Transport for NSW

Sydney Park Junction

Walking, cycling and public domain improvements

Submissions report

Figure A-1 | Refinements to the proposal
Sydney Park Junction

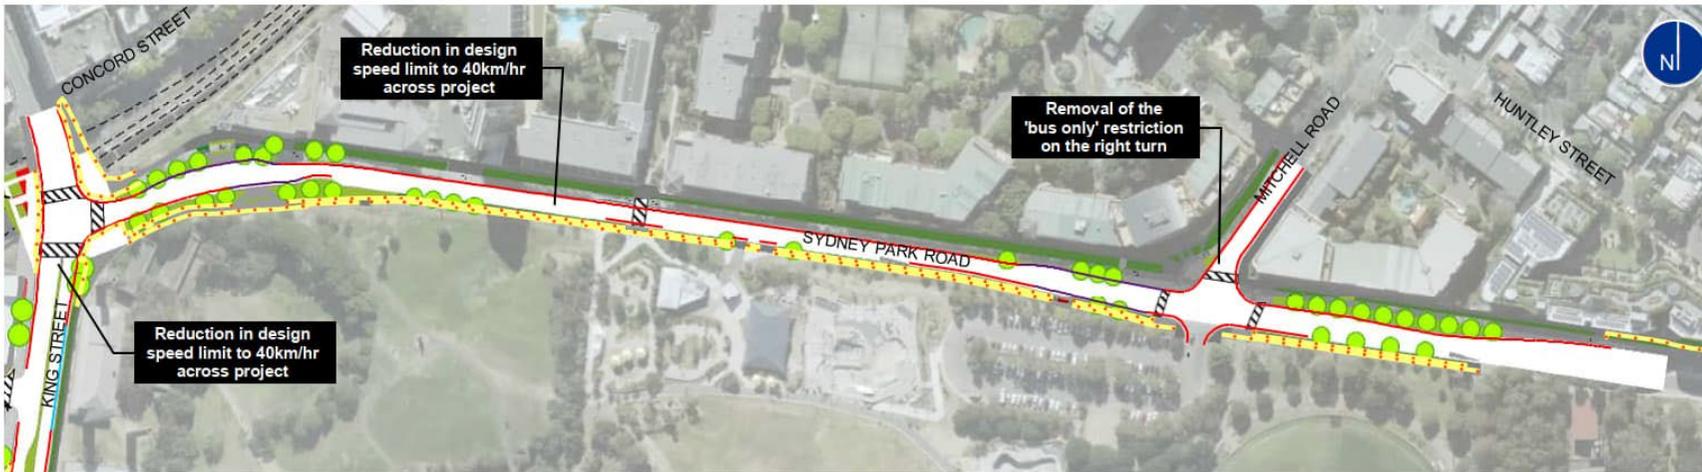
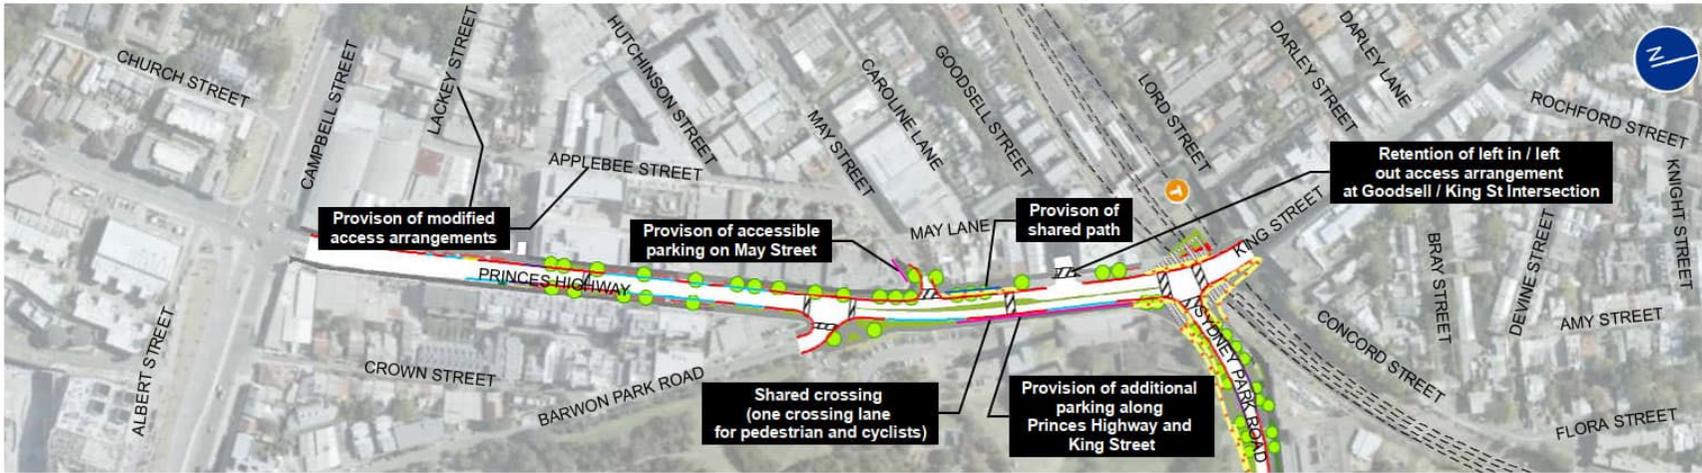
The key features of the proposal were described in Chapter 3 of the Sydney Park Junction Review of Environmental Factors (REF) prepared by Transport for NSW in July 2021. Transport for NSW has since refined the proposal design in response to issues raised in public submissions and during design development (refer to **Figure A- 1**).

- Reducing the Princes Highway/King Street carriageway from six lanes (generally) to four lanes (two lanes off-peak) from Campbell Street to Sydney Park Road, to accommodate an on-road two way segregated cycleway (on the western side of King Street between May Street and St Peters Square), additional landscaping and community spaces to increase urban amenities. The existing pop-up cycleway along Sydney Park Road would remain operational until construction of the proposal

- Reducing the Sydney Park Road carriageway from four lanes to two lanes to accommodate a permanent solution for the existing temporary on-road two way (pop-up) segregated cycleway (northern side), parking and additional landscaping to increase urban amenities

Figure 4-1 | Refinements to the proposal
Sydney Park Junction

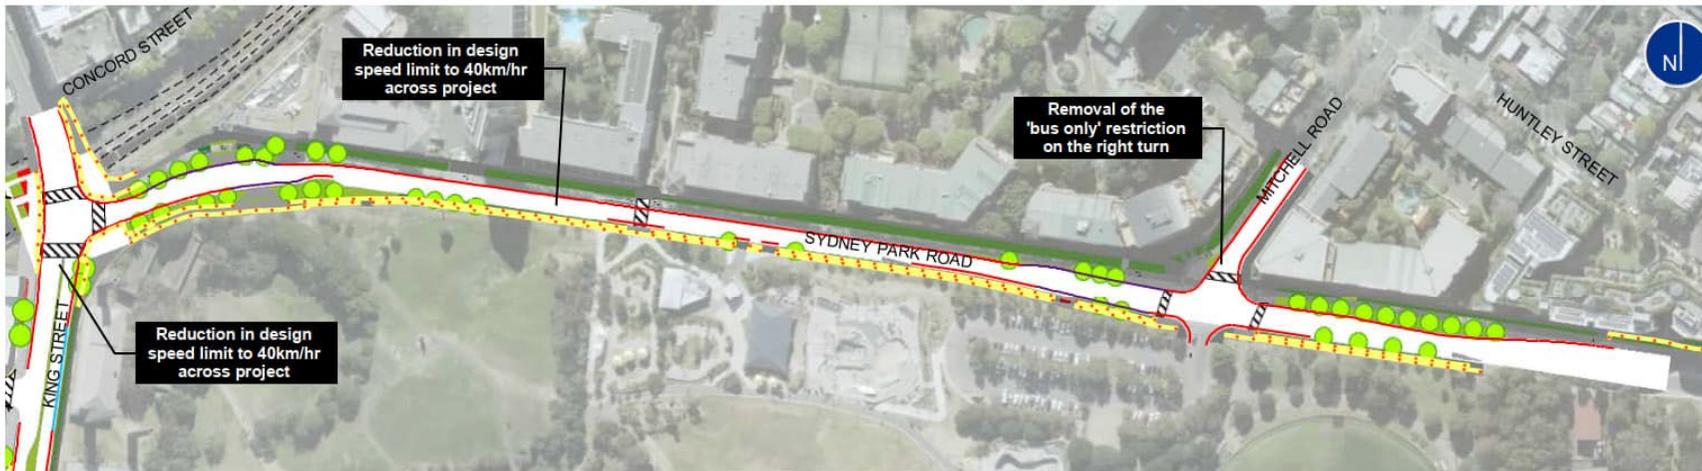
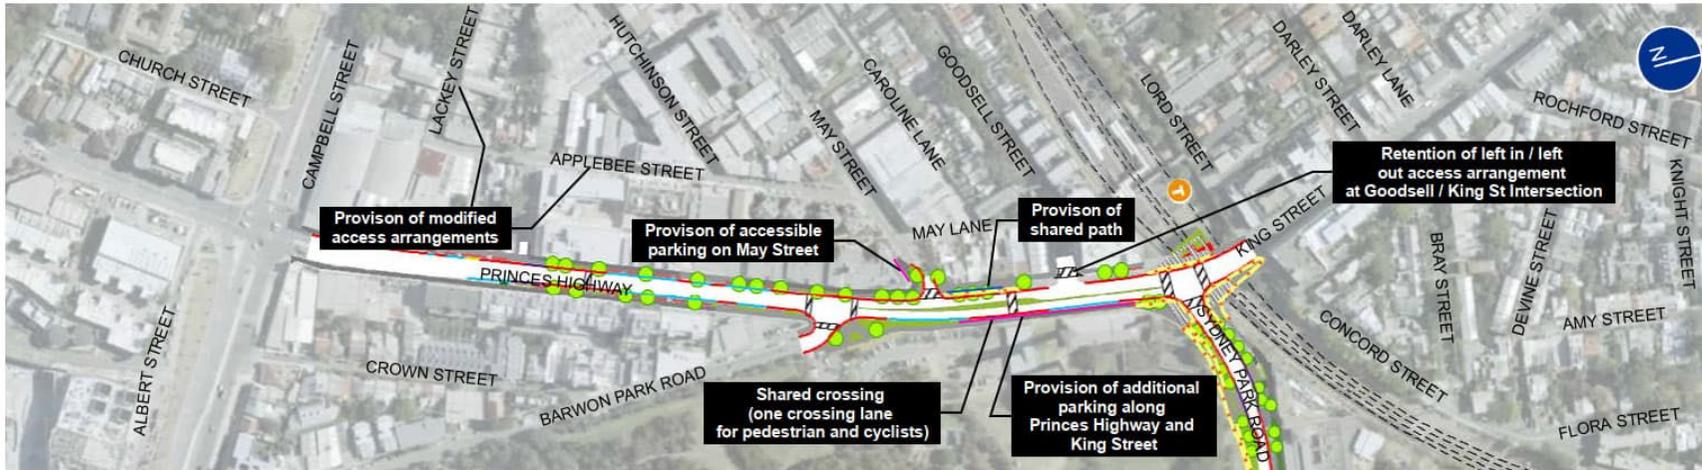
The proposal as described in the REF did not include the provision of accessible parking spaces. Due to concerns raised about the availability of parking spaces for people with less mobility, the design has been updated to include the provision of one accessible car parking space on May Street, as shown in **Figure 4-1**.

The existing footpath along the western side of King Street between the proposed on-road two way cycleway and May Street has been reassigned as a shared path to allow cyclists to cycle off road between the cycleway and May Street and improve safety and connectivity for cyclists. The location of the shared path is shown in **Figure 4-1**.

The environmental assessment carried out for the REF was based on the detailed design. Since display of the REF further refinements have been made to the final design. These changes to the proposal are minor and do not extend outside of the proposal area assessed in the REF and do not affect the environmental assessment. The design refinements to the final design include:
